5-4-90

FROM: John Carson, Rodger Bossert

SUBJECT: 50mm SSC Cable Size and Cross Section Status

Figure 1

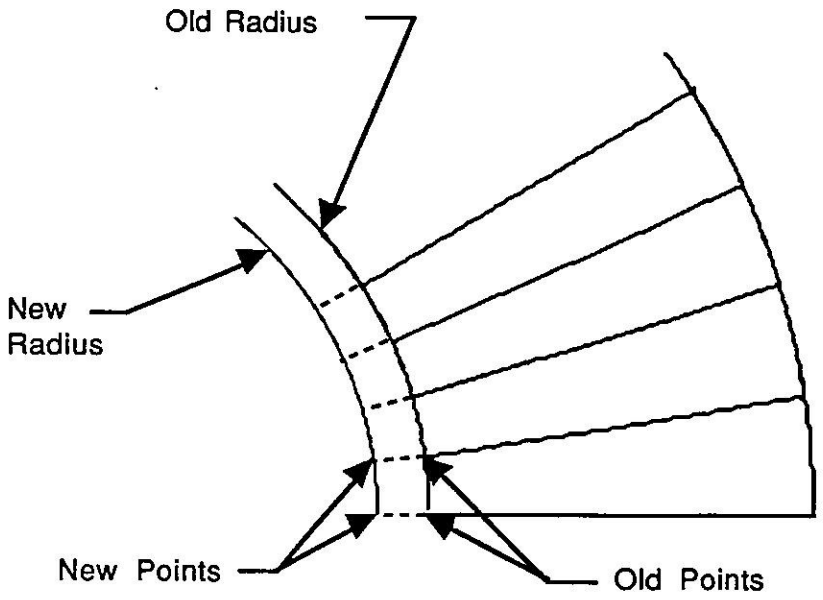
Concerning the cross section itself: All coordinate points for insulated cable corners stay the the same except the inner coordinates of the inner cable. These points will now be at the intersection of a circle of .9753 radius and the lines representing the sides of the present inner cables as shown in Figure 1. Cross section drawing #292000 should be changed to reflect this.

Outer coil outer radius = 1.9583 inches +.001/-.000 (same as on 292000)
Outer coil inner radius = 1.4847 inches +.000/-.001 (same as on 292000)
Inner coil outer radius = 1.4747 inches +.001/-.000 (same as on 292000)
Inner coil inner radius = .9753 inches +.000/-.001 (.009 less than on 292000)

Figure 2

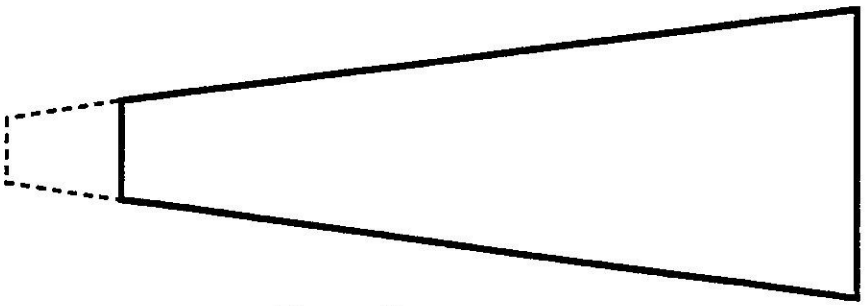
The cable width, however, will be increased in a way which is not entirely consistent with the way the cross section is being changed. In the cross section the keystone angle and high end thickness are being held while the low end thickness is allowed to change as shown in Figure 2. On the cable the high end and low end thickness are being held while the keystone angle is allowed to change as shown in Figure 3. This will result in the condition seen in Figure 4, where the cable insulation must compress more at the thin edge than the thick edge. The extra compression is on the order of .0001 per side, so the present thinking is to disregard it.
